Remarks

Amendment to the Drawings

FIG. 6

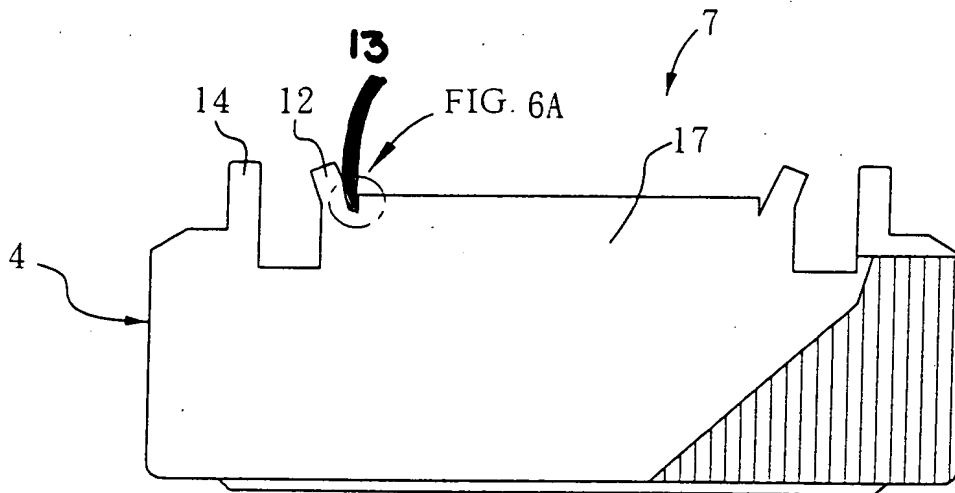
The attached sheet of drawings should replace present sheet 6 of drawings and includes a change to Fig.6. Fig. 6, is amended to included reference number 13 and removal of the word "kink".
